CITY OF MARLBOROUGH MEETING POSTING

Meeting: Planning Board
Date: January 25, 2021
Time: 7:00 PM
Location: REMOTE MEETING NOTICE

Subject: Four-Lot Subdivision, 76 Broad Street, Marlborough, MA
Response to Engineering Division review comments

UTILITY PLAN

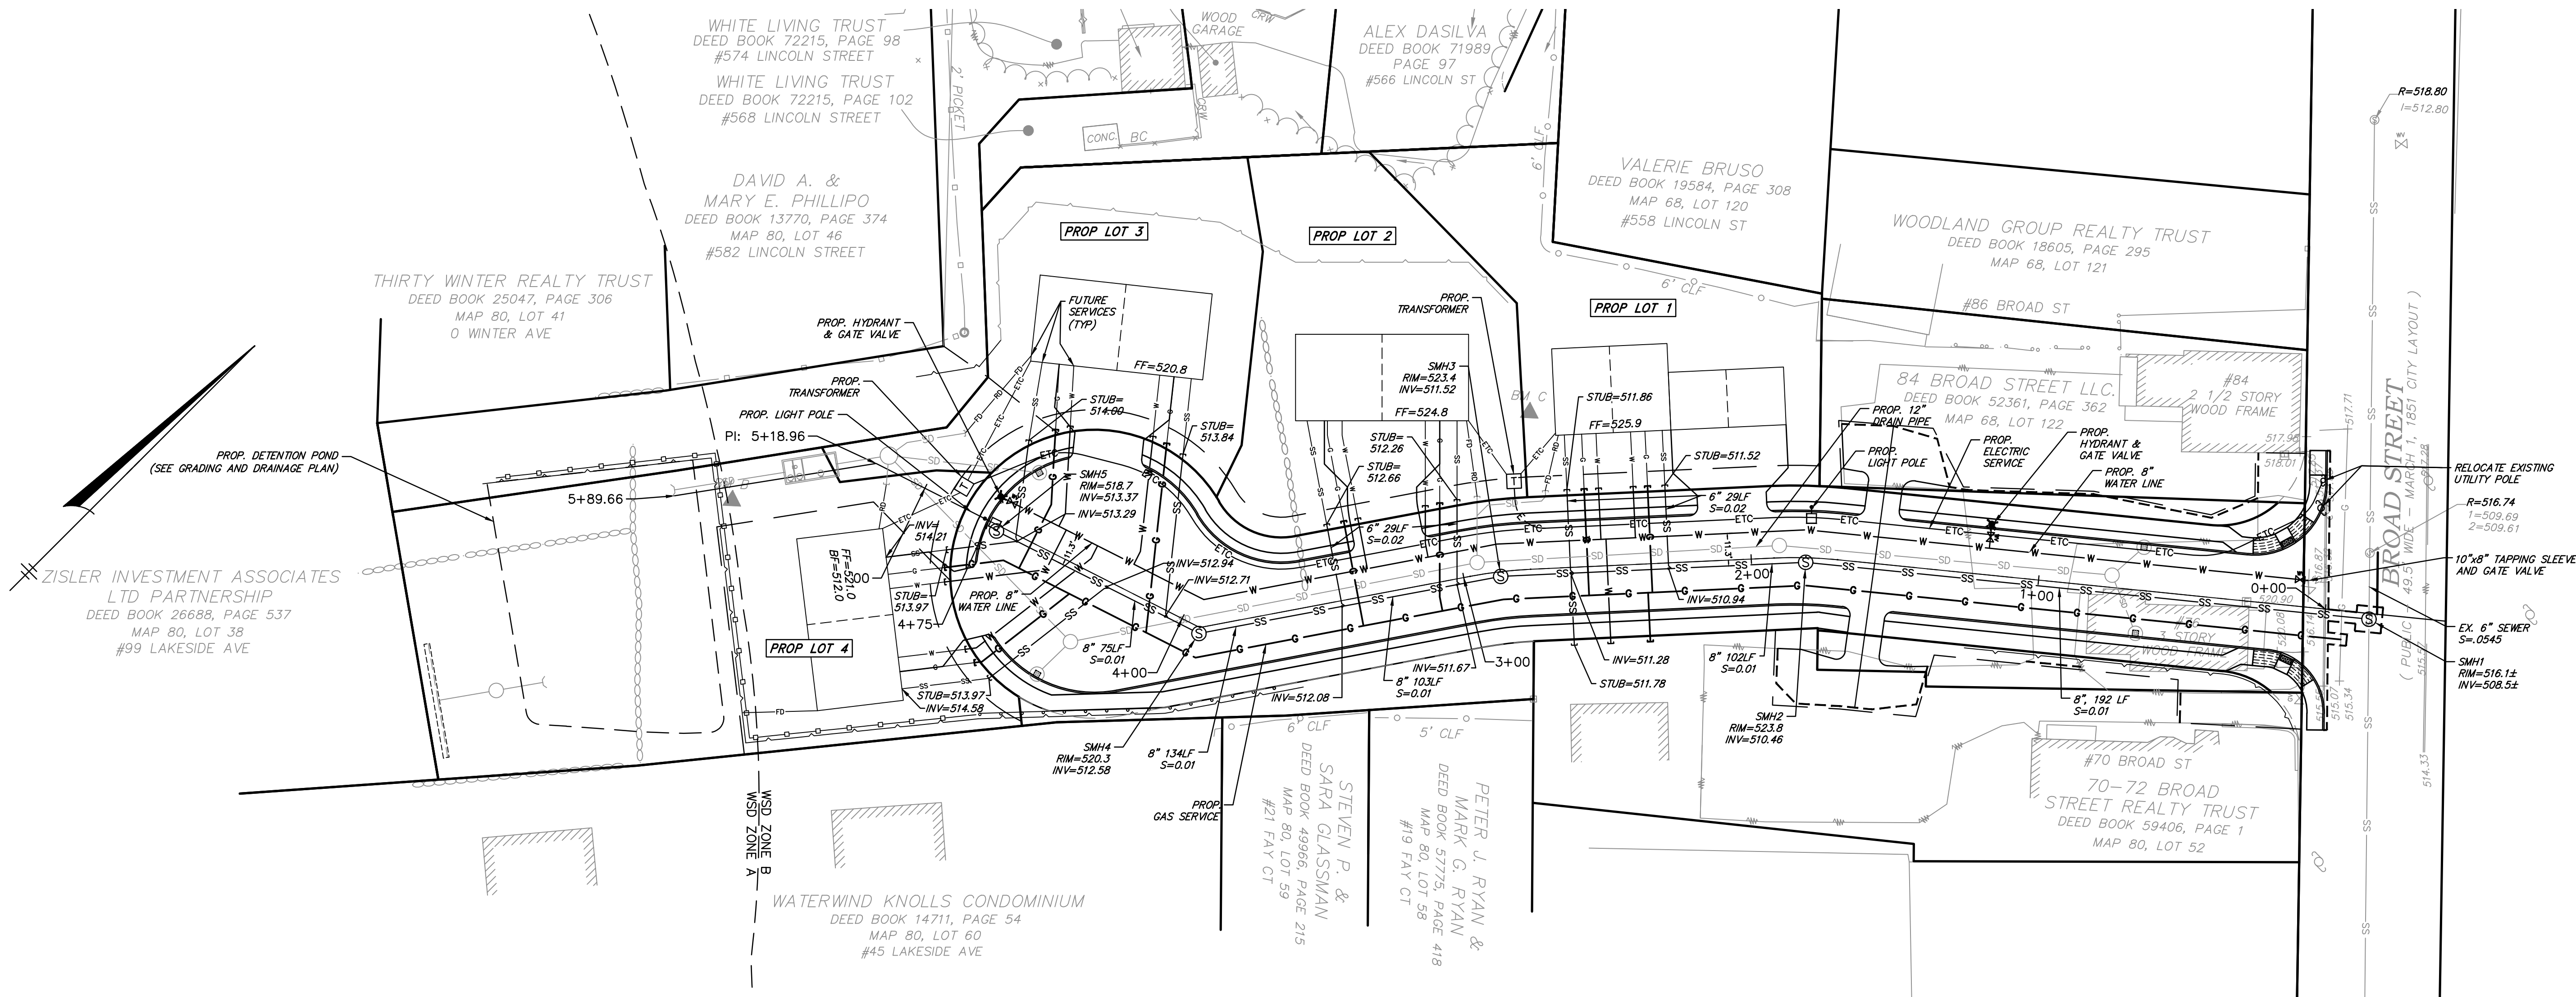
- In order to eliminate the crossing of "shallow utilities" (gas, electric, cable & telephone) with Water, sewer and Drain pipes, add the following note: "All utility excavations regardless on the depth or the means of any excavation shall require Dig Safe notification and must apply for a Road Opening/Trench permit with the DPW-Engineering Division."

Response: Note 6 has been added to Sheet C7.

PLAN AND
PROFILE

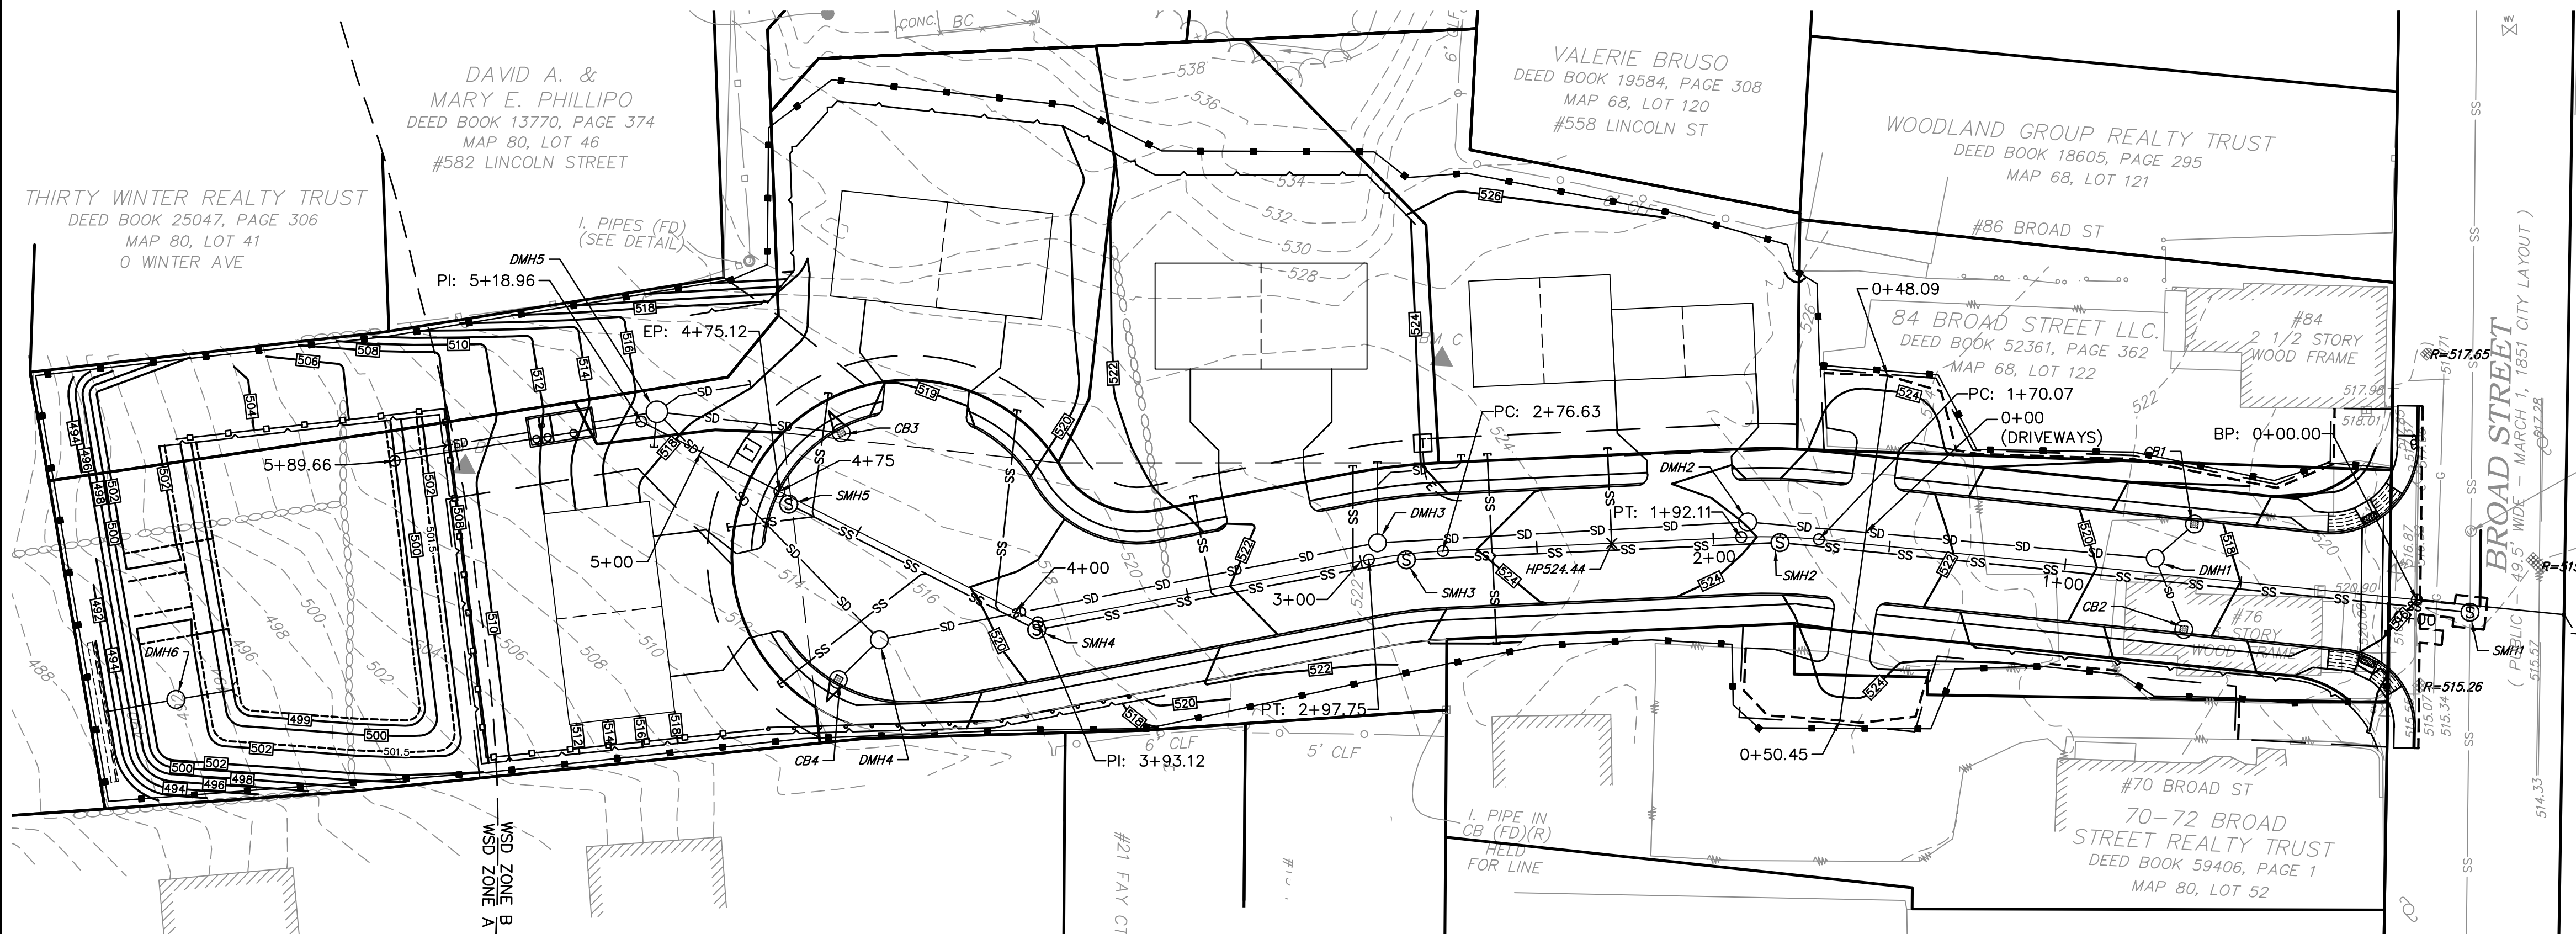
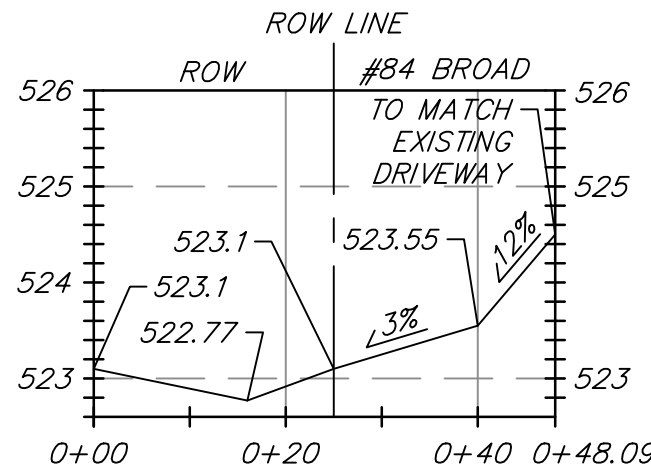
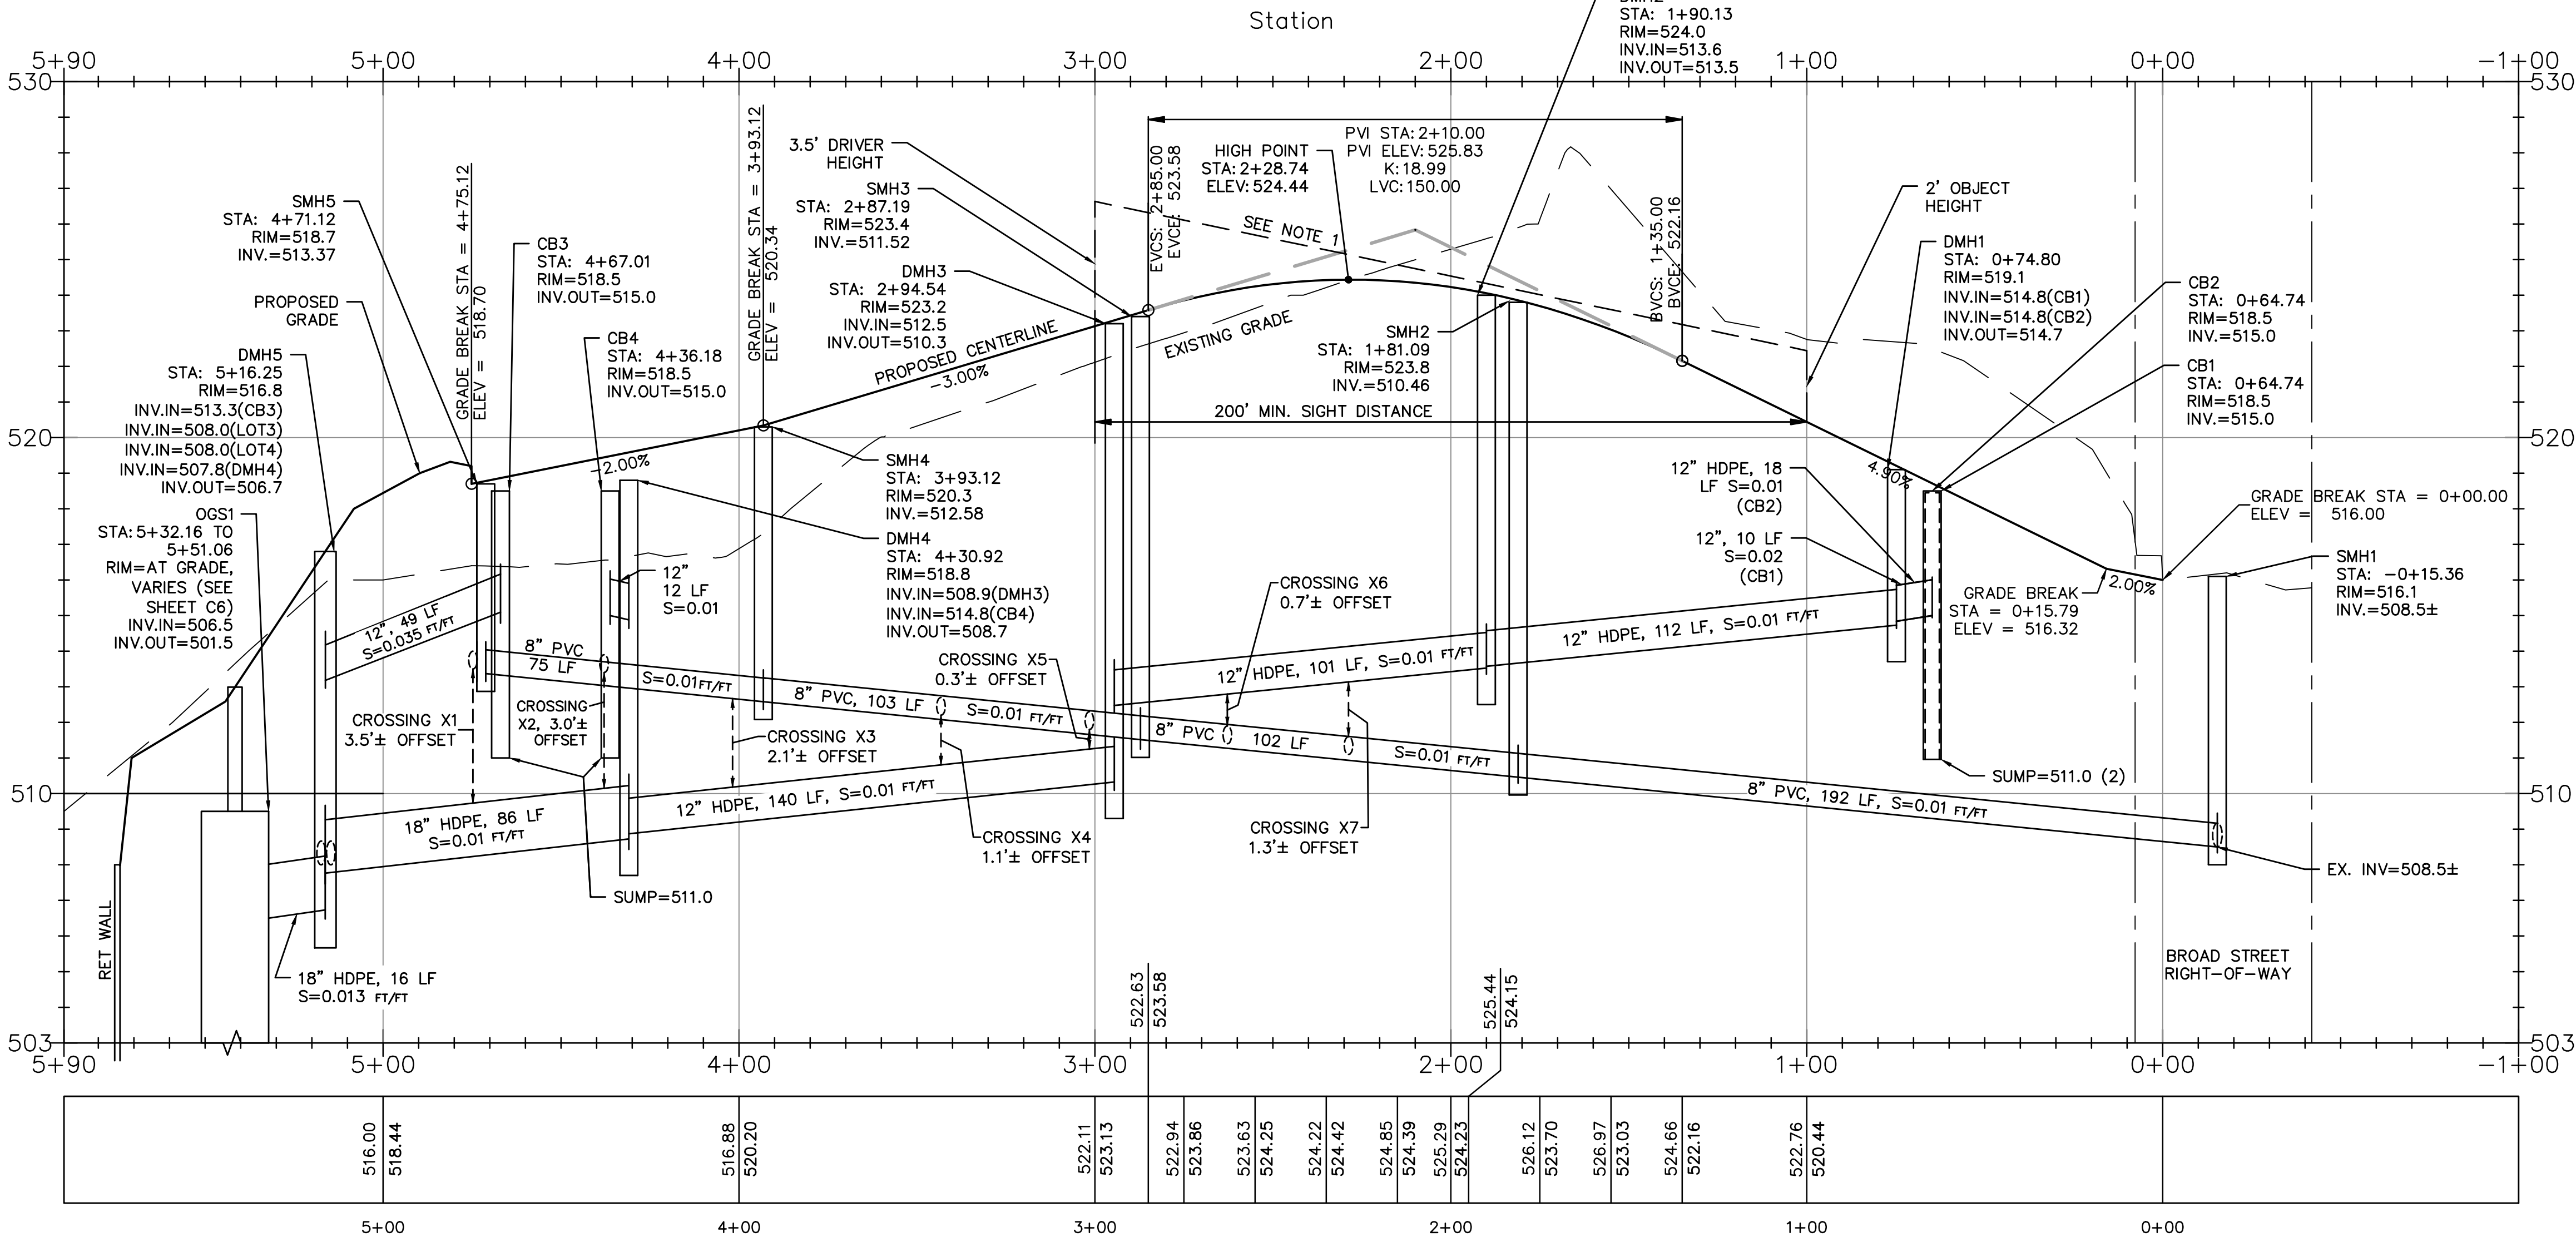
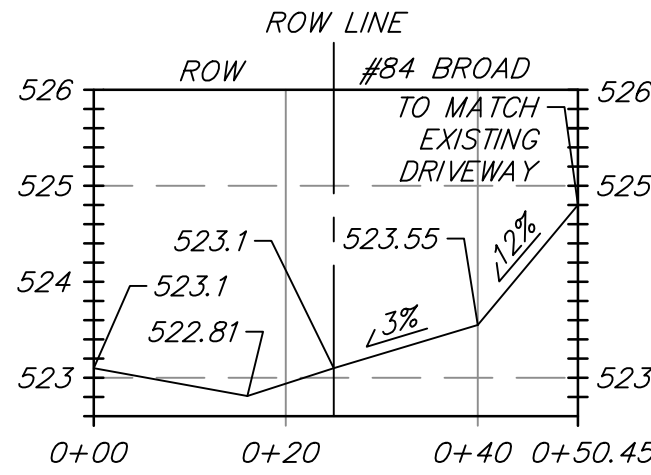
- Plan and Profile should extend through the detention basin pass the property line for the project.

Response: Driveway profiles for both driveways have been added to Sheet C8. The sawcut lines on Sheet C5 have been revised.

Response: Section A-A on Sheet C6 depicts a cross-section of the detention basin and outlet structure in the direction of the profile shown on Sheet C8.
